Review of US EPA's "Draft Investigation of Ground Water Contamination near Pavillion, Wyoming"

Halliburton Energy Services, Inc.
P.O. Box 42806
Houston, TX 77242-2806

Gradient
20 University Road
Cambridge, MA 02138

June 25, 2012

Figure 2.1 Regional Depth Trend in Groundwater Data Indicates Downward Flow

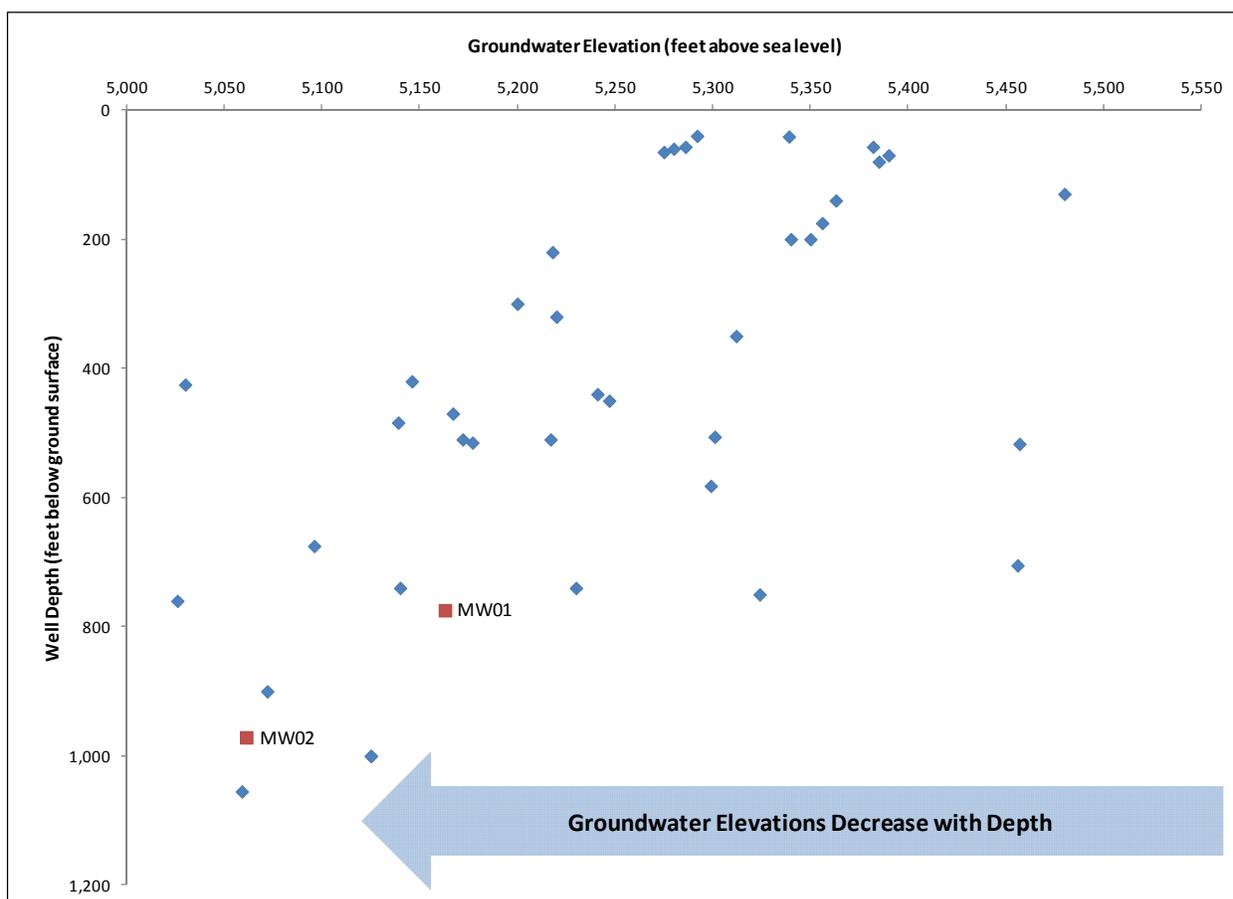
Another approach for determining the vertical direction of groundwater flow is to plot groundwater elevations from wells within a region against well depths. If groundwater elevations decrease with depth, this is an indication that flow is downward. We undertook such an analysis with recent groundwater data, which is shown in Figure 2.1 (data from James Gores and Associates, 2011). This plot shows that groundwater elevation decreases with depth in the Pavillion area, indicating that groundwater flow is downward. Note also that the water levels for MW01 and MW02 plotted on Figure 2.1 are also consistent with a downward regional hydraulic gradient.

Figure 3.1 Water Level Measurements in MW01 and MW02

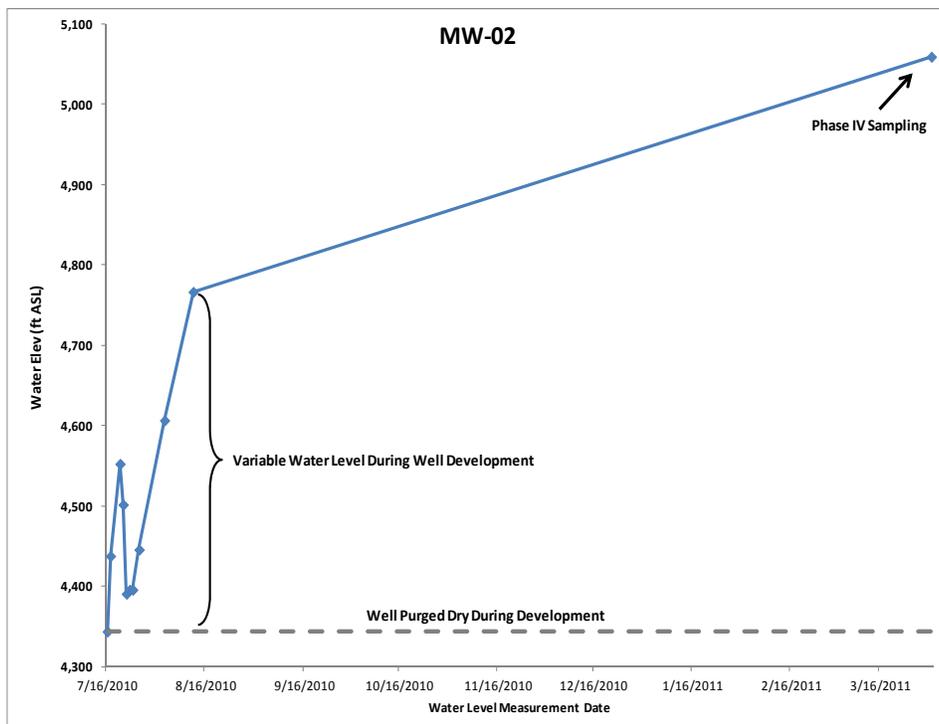
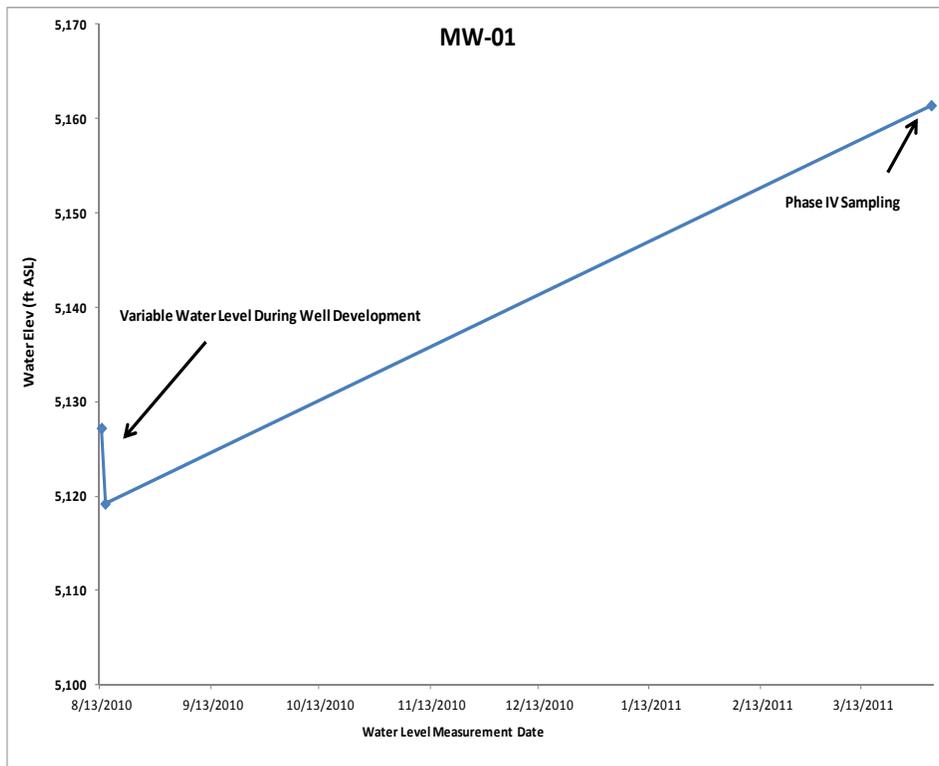
At MW01, a sufficient volume of water was removed (10,960 gallons) and a turbidity reading below 10 NTU was achieved; however, temperature, pH, and conductivity were not recorded and may not have stabilized. At MW02, less than two (2) well volumes were removed before well development was halted due to methane accumulation in the well. The slow recharge rate at this location (*e.g.*, as shown in Figure 3.1, approximately one month after well development in 2010, the water level in the well was still 89 meters (293 feet) below the static water level measured in March 2011) is a potential indicator of inadequate well development (including an indication of clogged well screen), or of a zone that is incapable of delivering enough water to qualify as a USDW, or a combination of both. Moreover, the Work Plan-established turbidity target was not reached, and the other required parameters were not recorded.

At both deep monitoring wells, water jetting (injection of water into the well at the screened interval) was used to aid well development. No analytical samples of the water were collected, and thus the quality of the water added to the wells is unknown, which draws into question the reliability of sampling results from MW01 and MW02. Inadequate well development at MW02 renders the data collected from this well and the conclusions drawn from these data (*e.g.*, pH, potassium, chloride) unreliable.

Figure 3.2 Field Parameters Measured Prior to Sample Collection at MW02 (Phase III)

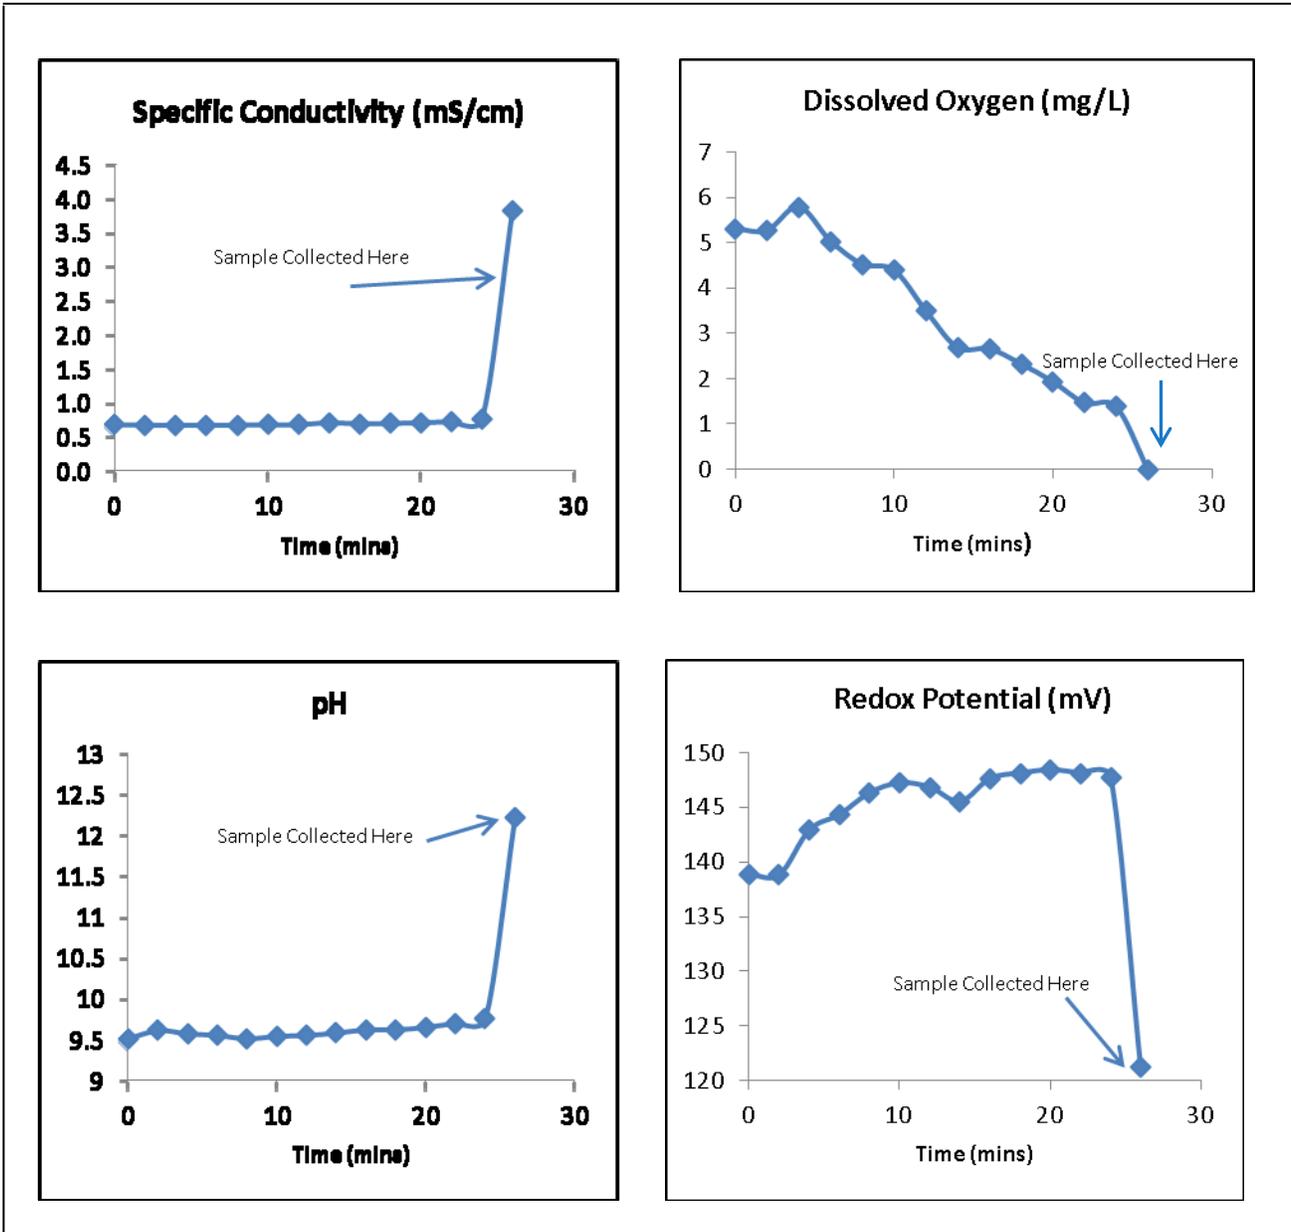
US EPA also ignored Work Plan requirements and standard protocols for sample collection that require collection of groundwater samples after field parameters (*e.g.*, pH, temperature, specific conductivity) have stabilized. The criteria to be used for defining stabilization of field parameters were defined in the project Work Plan (US EPA Region I, 2010) and are summarized below (Table 3.1):

However, US EPA collected groundwater samples at the deep monitoring wells during Phase III of the Study, when field parameters had not stabilized (Table 3.1 and Figure 3.2). In fact, the field monitoring data reported in field logs demonstrate that water with dramatically different geochemistry had entered well MW02 immediately prior to sample collection (Figure 3.2) and demonstrated significant violations of the stabilization criteria defined in the Work Plan (Table 3.1). These data clearly demonstrate that stabilization had not been achieved prior to sample collection and that additional well development was needed at MW02. US EPA not only apparently ignored these data in the field, but it failed to present or acknowledge these data in its report (US EPA, 2011).

Figure 4.1 Comparison of Hydrocarbon Distributions in Gas Condensate Sample PGPP06 and Deep Monitoring Well MW02

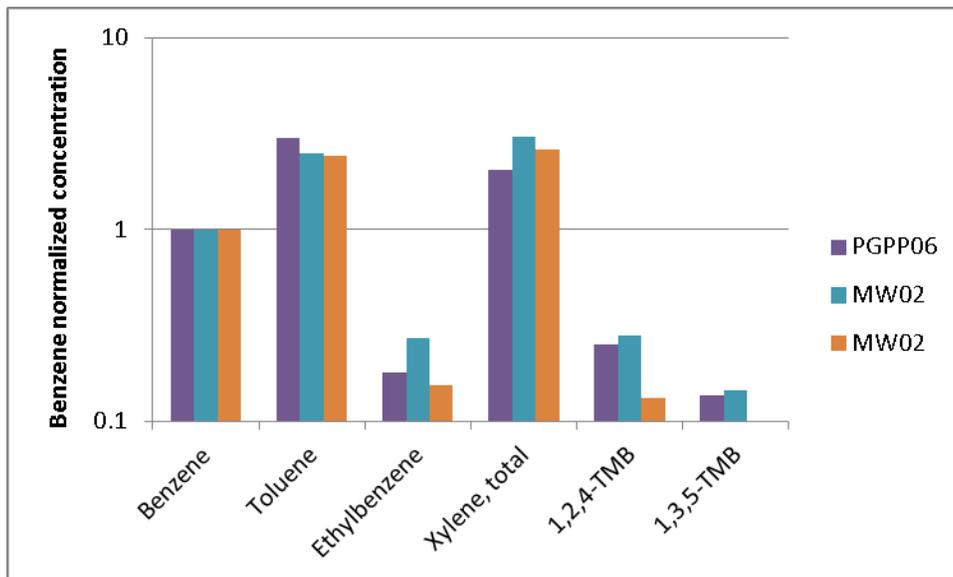
One of US EPA's other lines of reasoning is that petroleum hydrocarbons (BTEX, trimethylbenzenes, naphthalene, GRO, and DRO) were detected in one or both of the deep monitoring wells (US EPA, 2011, p. 35). The detection of many constituents is questionable, however, given the contamination of field blanks (Sections 3.4 and 4.6). Thus, US EPA's data are not reliable for drawing conclusions about the presence or migration of contaminants. However, even if one assumes that the data are valid, the data would indicate that hydrocarbons found in the deep monitoring wells are consistent with those associated with natural gas, rather than providing evidence of hydraulic fracturing as suggested in the Study.

Figure 4.2 Concentrations of Diesel Range Organics (DRO) versus Depth

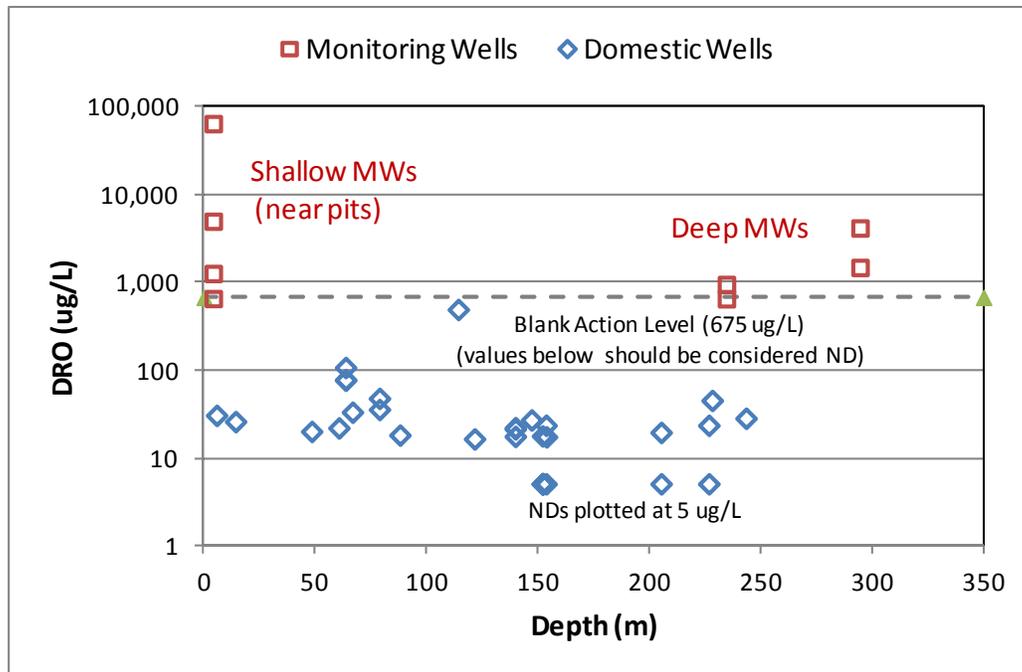
- The distribution of DROs in domestic wells is consistent with the natural presence of hydrocarbons and heterogeneity in the study area or an artifact of the poor sampling practices utilized in the Study (see Section 3). If there were a contaminant source present at depth and contaminated groundwater was moving upward, then concentrations should exhibit an increasing trend with depth. However, the DRO concentrations do not increase with depth (Figure 4.2). It should also be emphasized that, due to DRO in QA (blank) samples, the DRO results for the drinking water samples are all below the Blank Action Level and should be considered non-detects (see Section 3.4).

Figure 4-3 - Geologic Cross Section with Interpreted Lithology and Gas Shows
Pavillion Gas Field
Pavillion, Wyoming

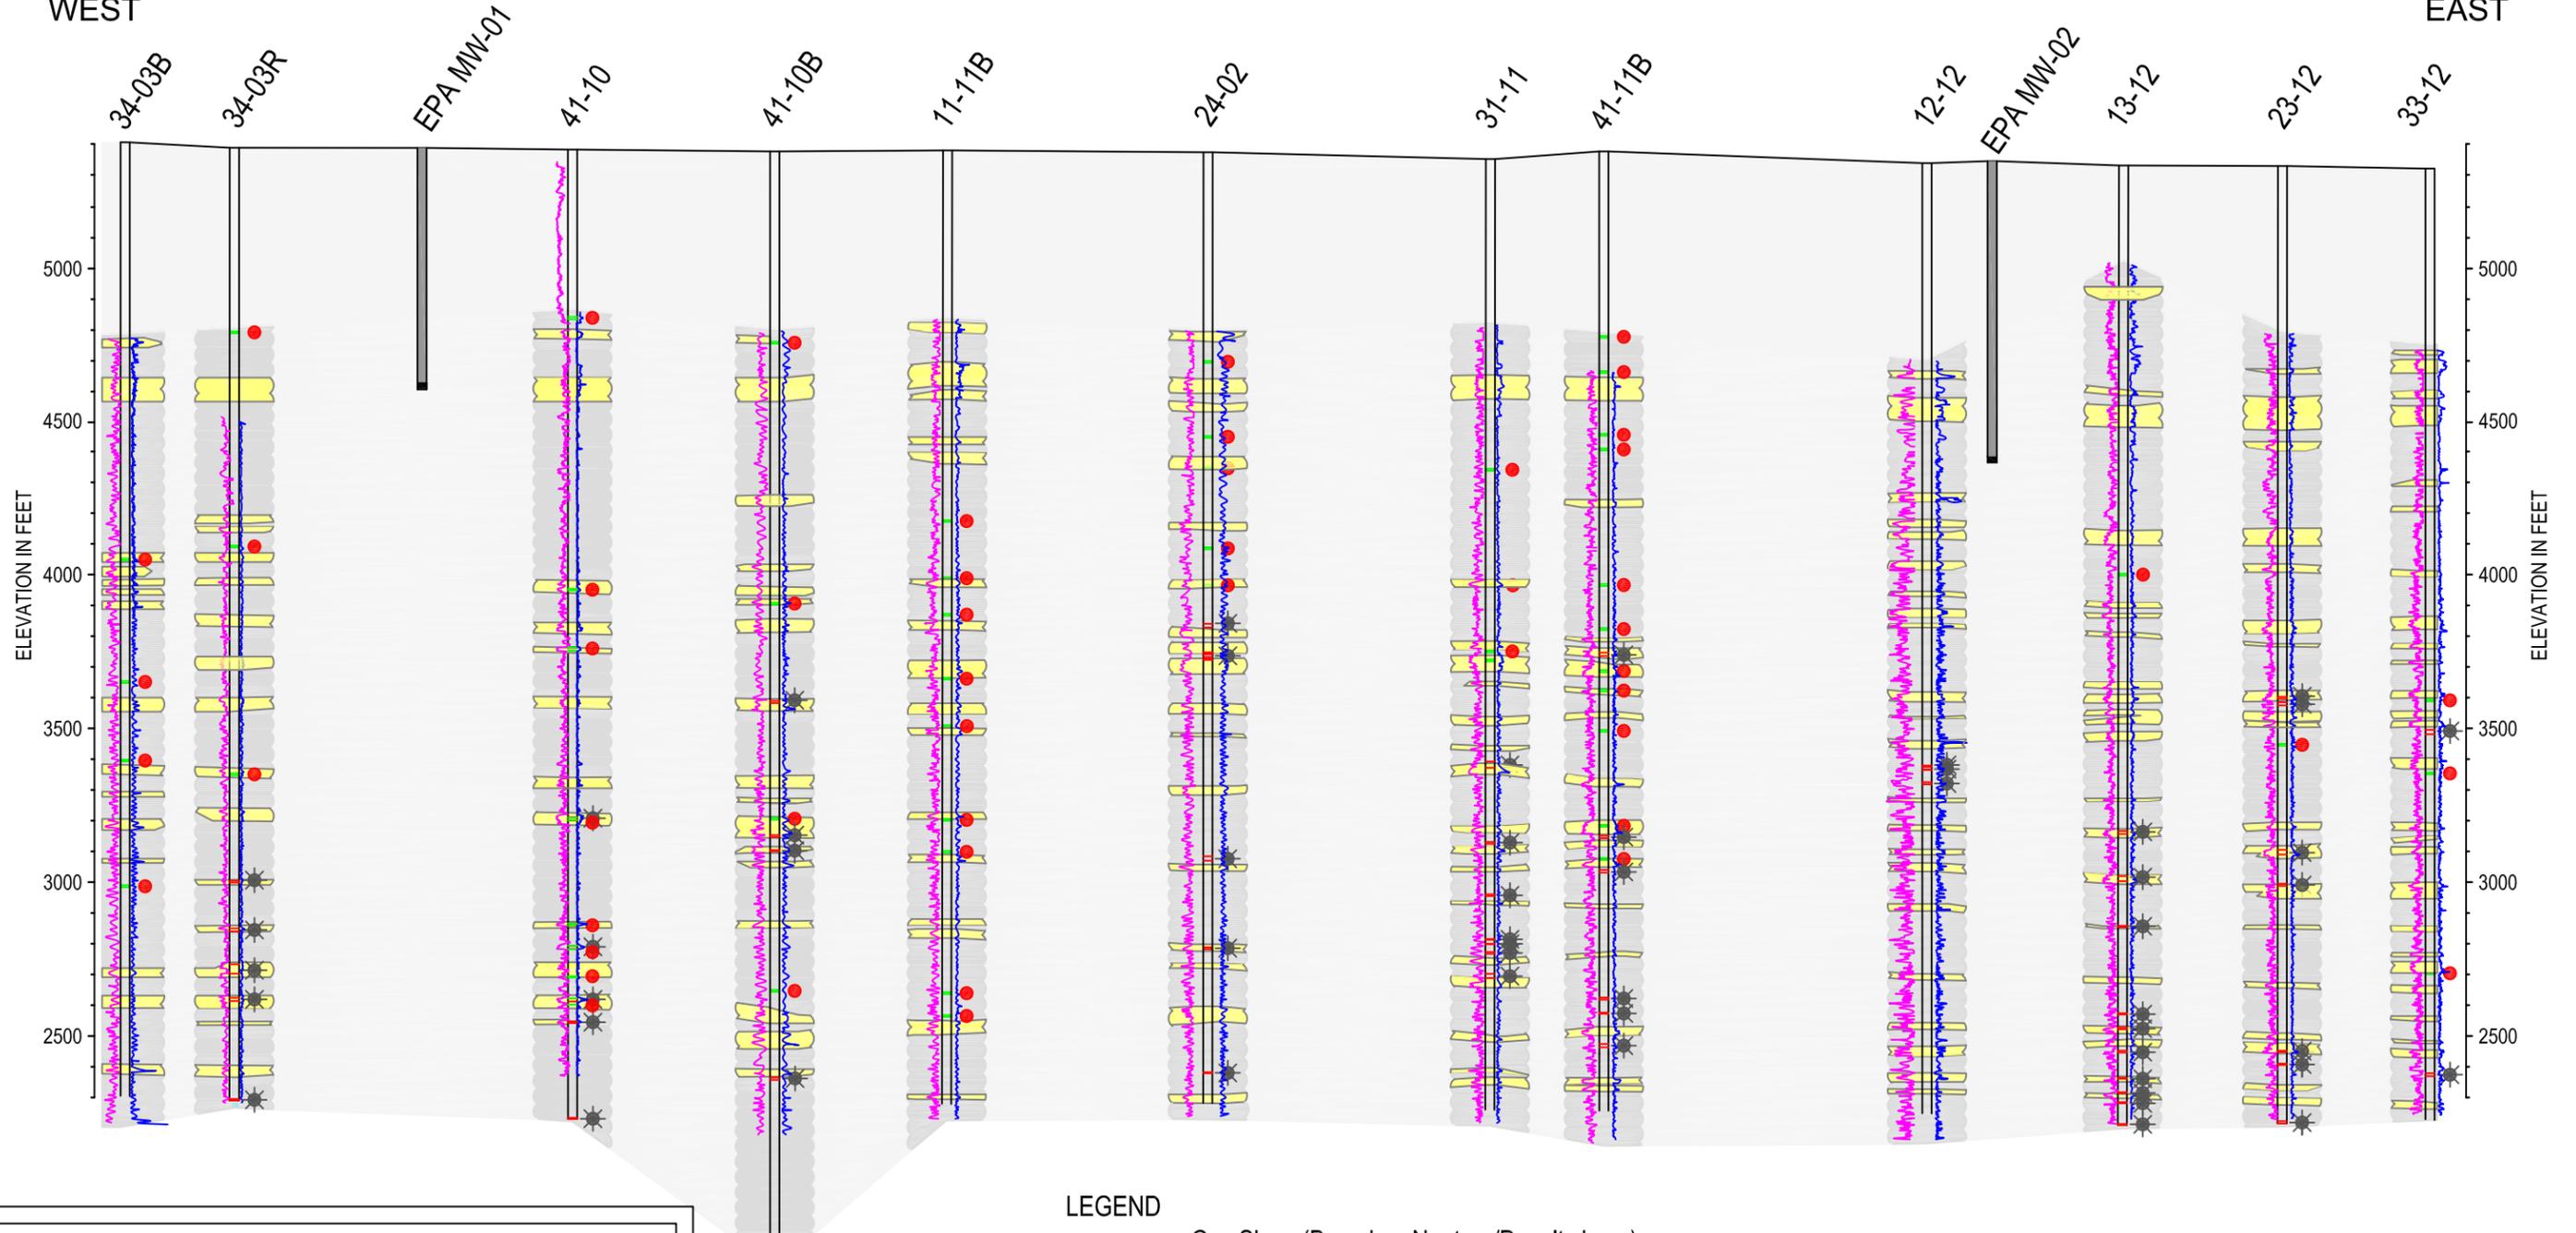
²⁸ The variable nature of "gas shows" within the Pavillion gas field is also shown in Figure 4.3. The gas shows on that figure are based on neutron/density logs, which like mud logs indicated in Table 3.1, are another method of assessing the likely presences of natural gas-bearing strata.

Figure 4.4 Methane in Drinking Water Wells as a Function of Proximity to Gas Wells

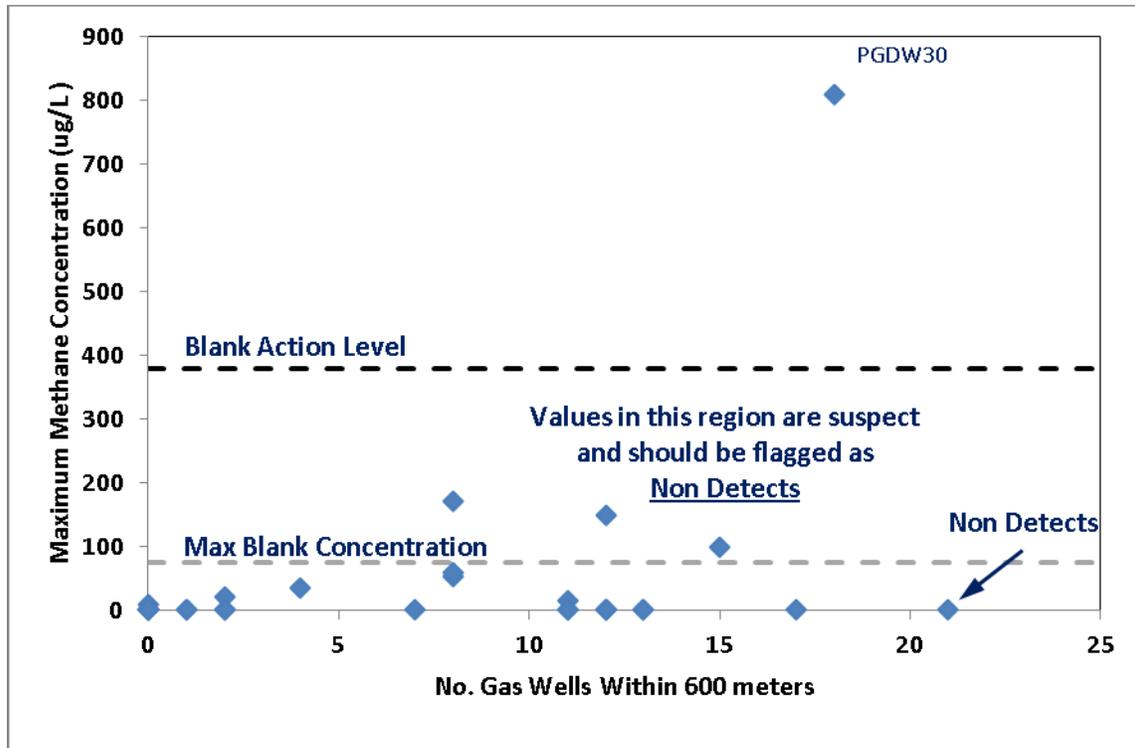
US EPA suggests that the methane concentration in domestic well samples is generally higher for those wells that are in proximity to gas production wells (US EPA, 2011, Figure 18c). That depiction of the methane data is misleading.

We have plotted the methane data for the domestic wells as a function of the number of gas production wells located within 600 meters (the same proximity used by US EPA, 2011, in Figure 18c). As seen in Figure 4.4, below, there is no discernible relationship between the methane concentrations in drinking water wells and the numbers of gas production wells within 600 meters. As the number of proximate gas wells increases, methane is just as likely to be non-detectable as it is to be detected. This result is not consistent with the hypothesis that natural gas production (or HF activities) have enhanced methane migration. If that were true, one would expect to see a clear relationship between higher methane concentrations *versus* the intensity of gas production and HF activities; there is no such relationship.
